PE12-014

12V-410
11 Pages

PART 573 Defect and Noncompliance Report

Date: August 14, 2012

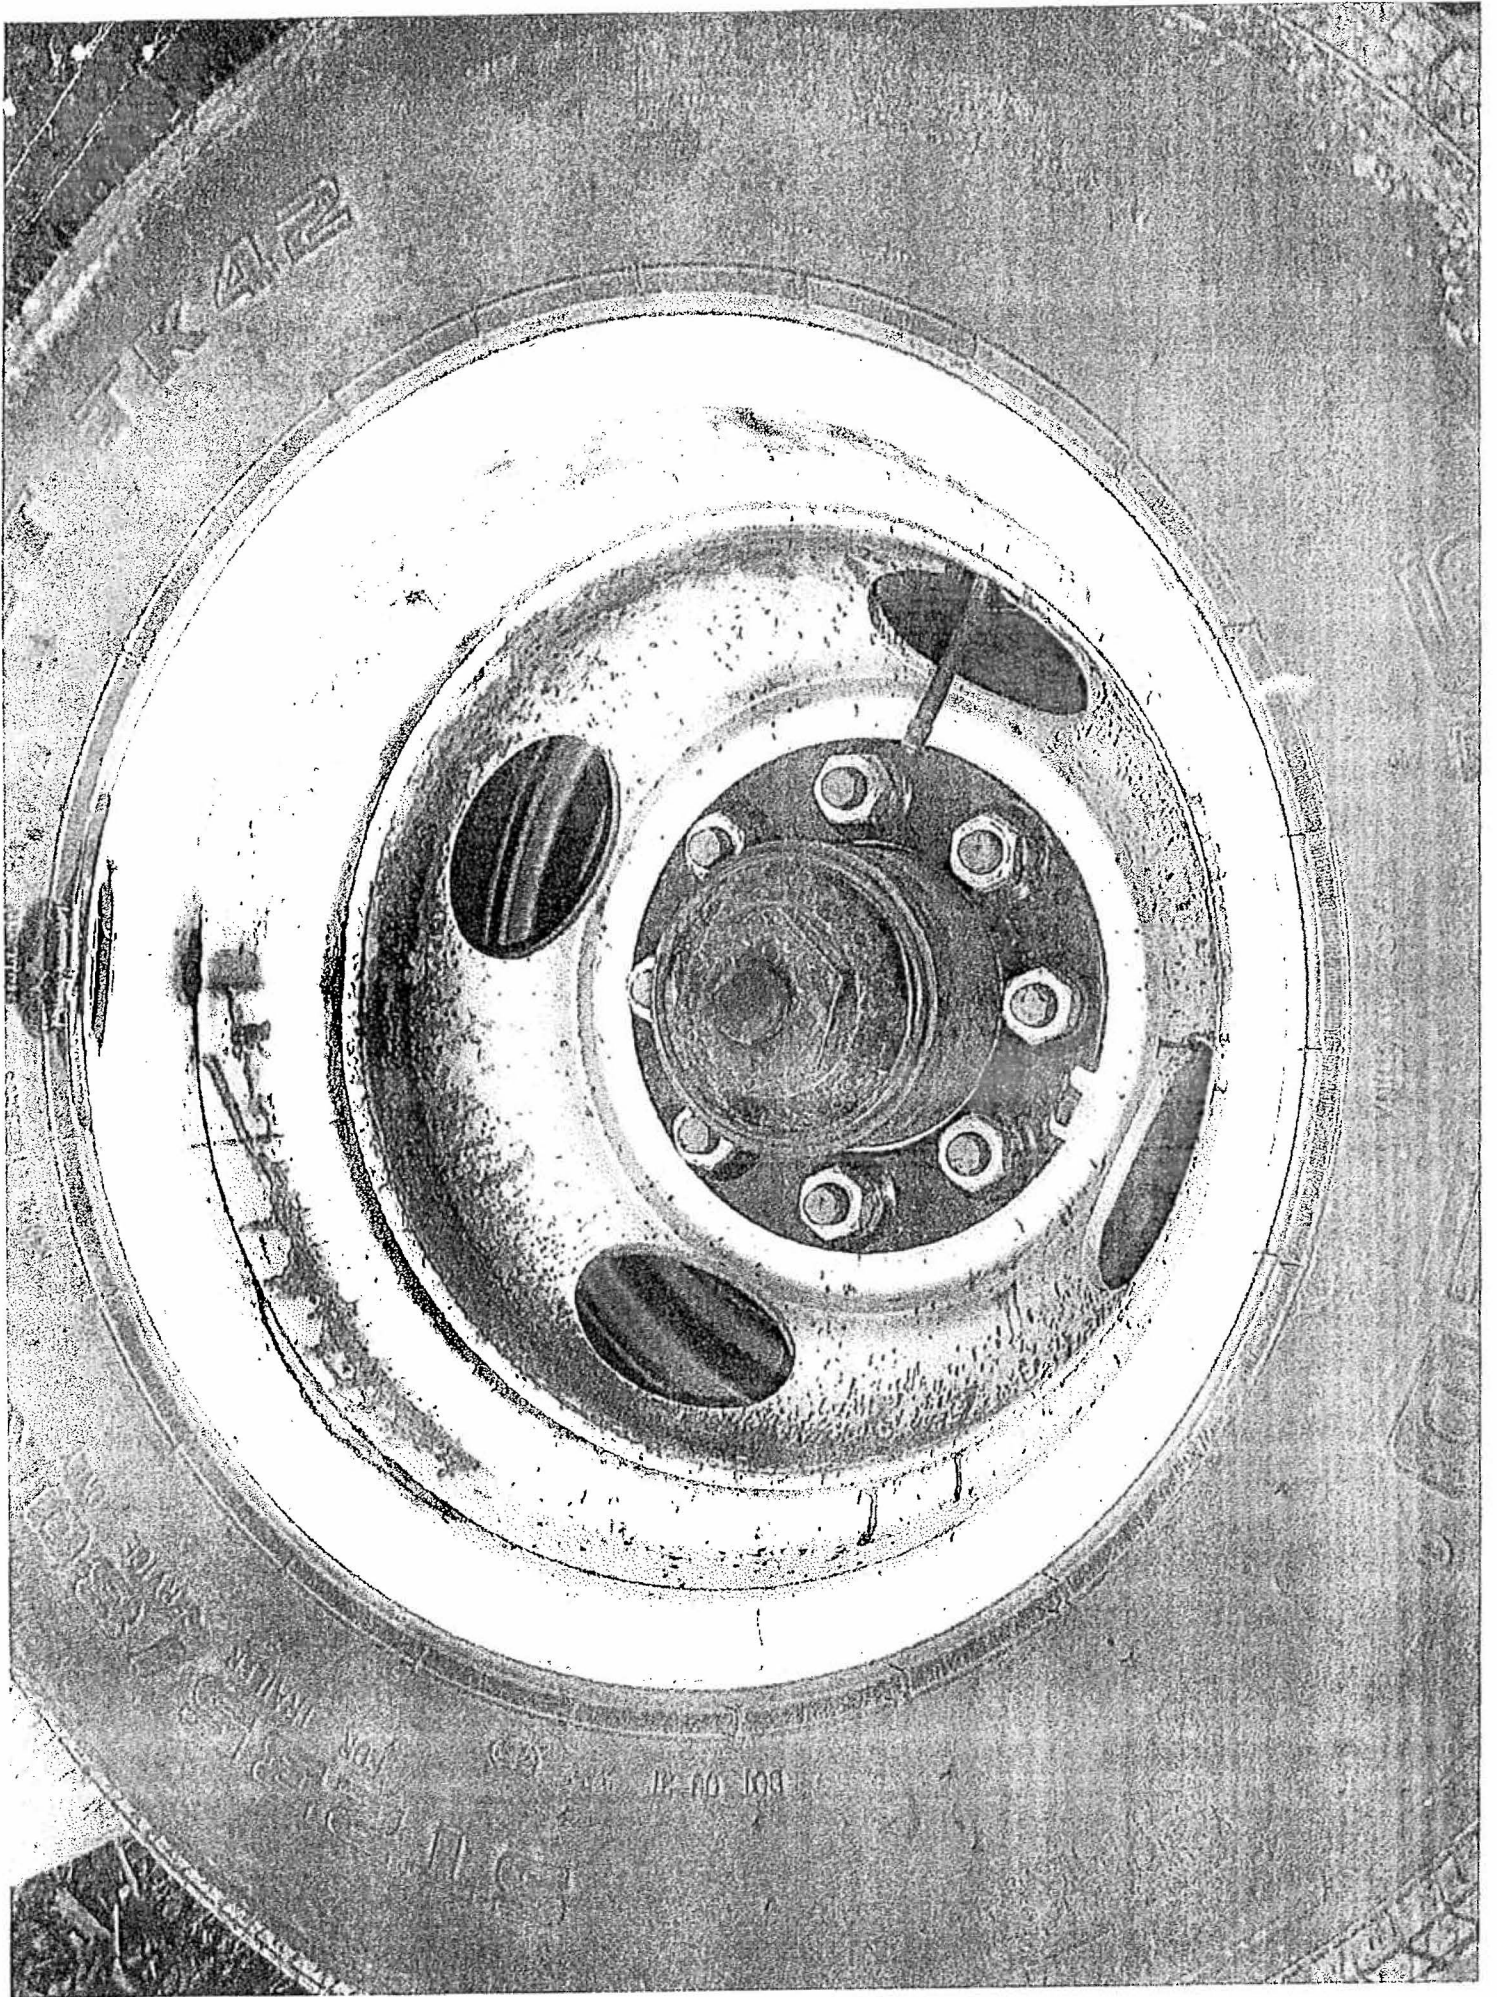
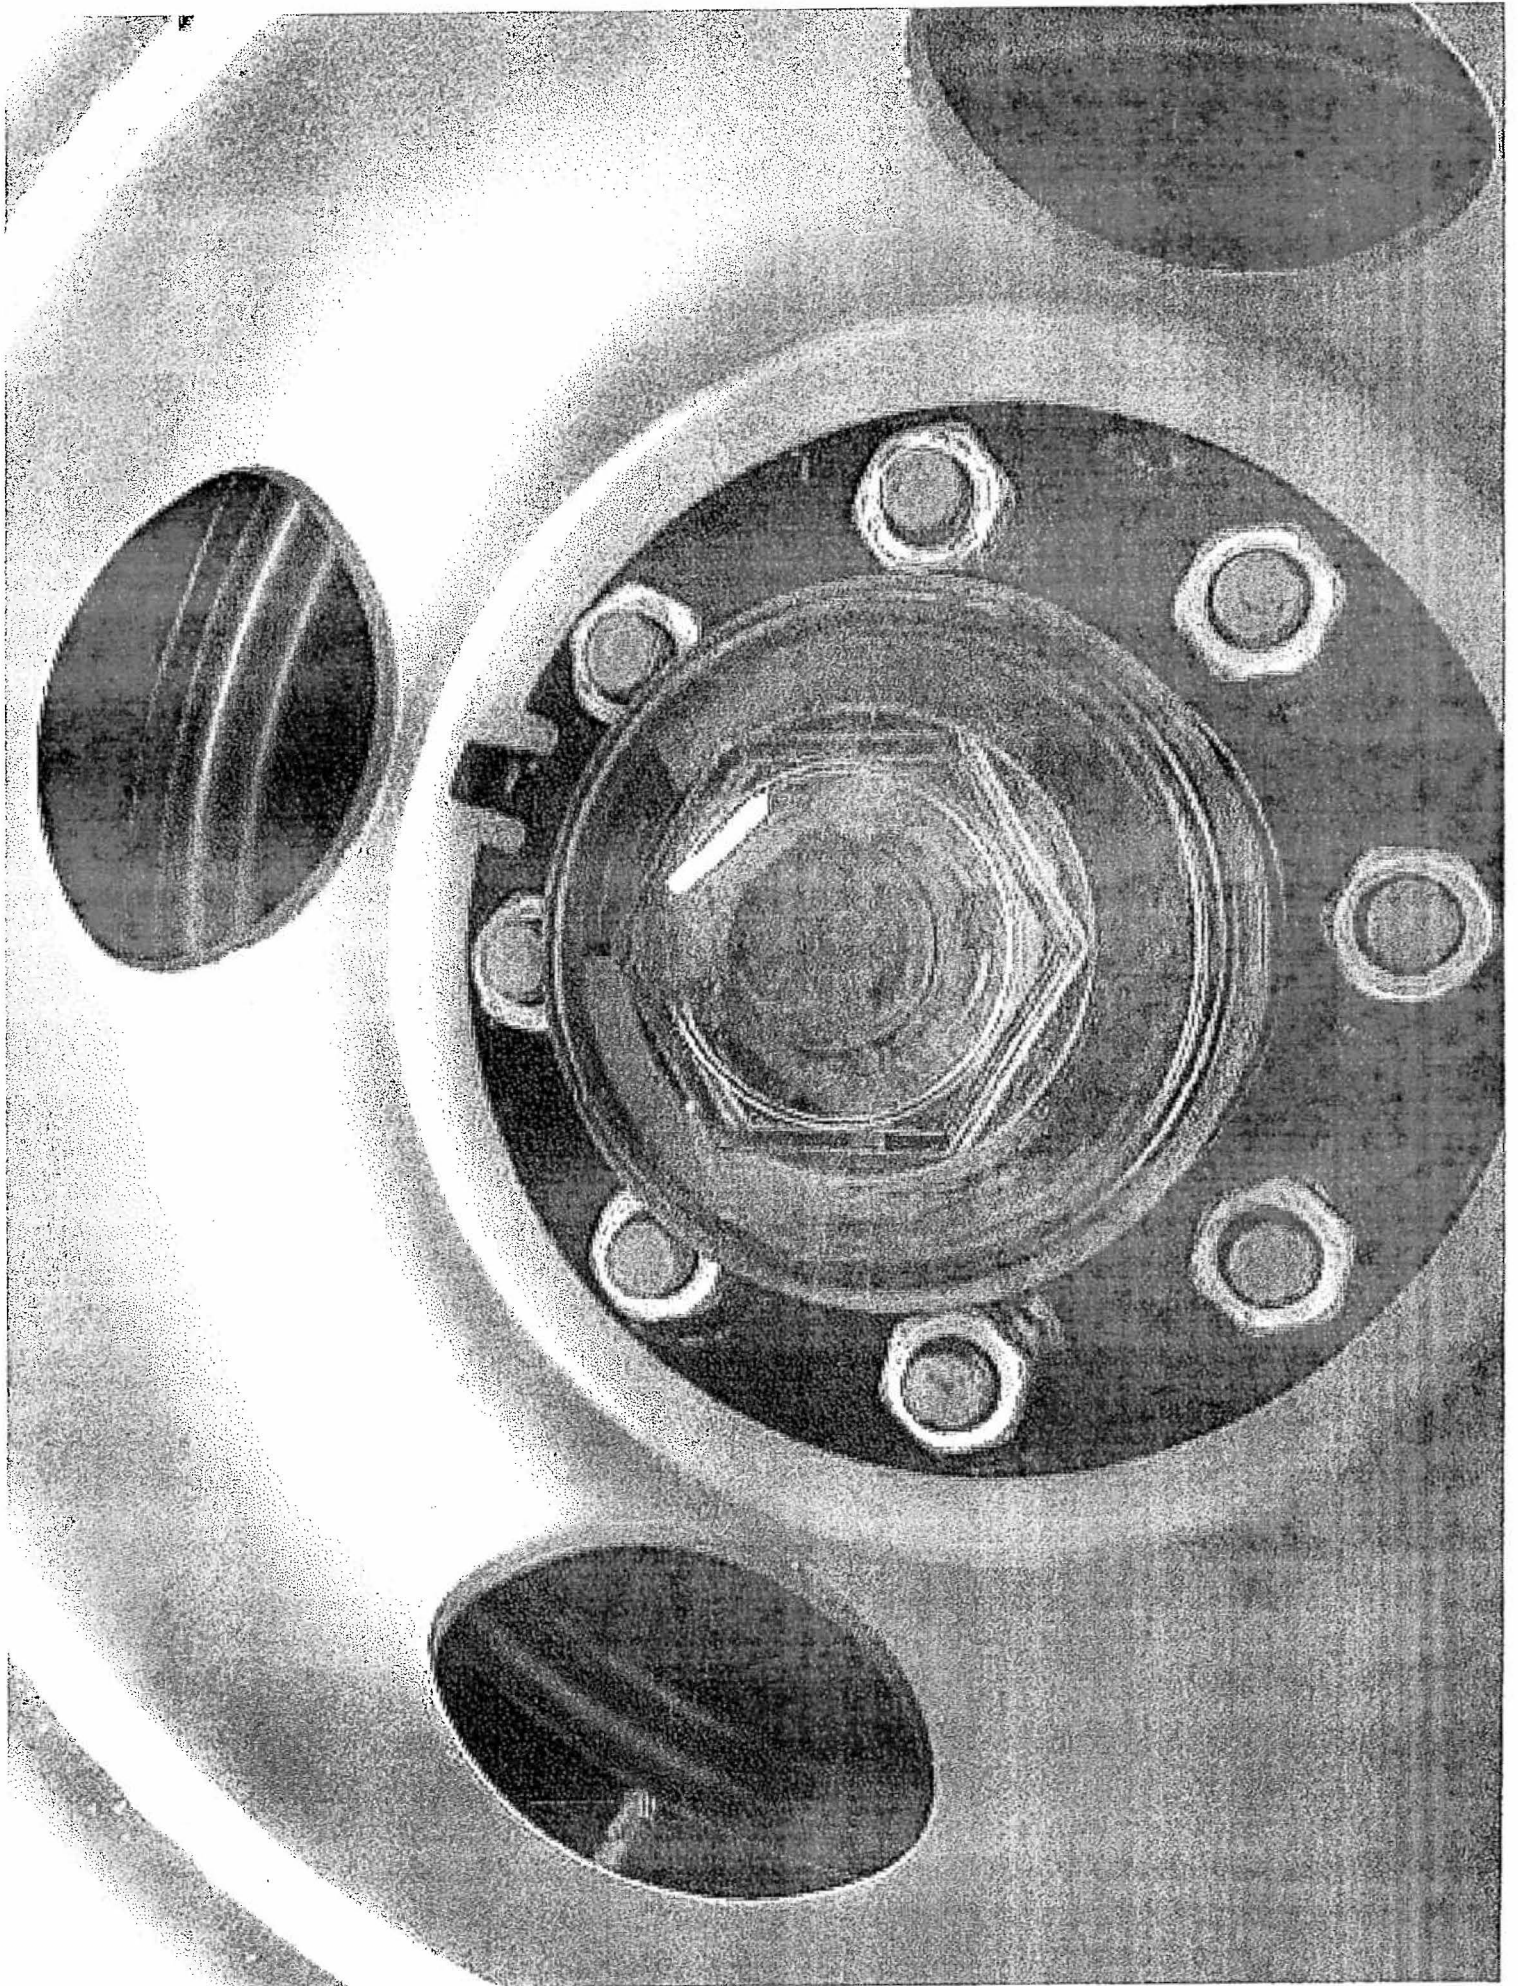
Clearly describe the distinguishing characteristics of the remedy component/assembly versus the recalled component/assembly.

The replacement wheel end "cap" will look very similar if not identical to the one being replaced.
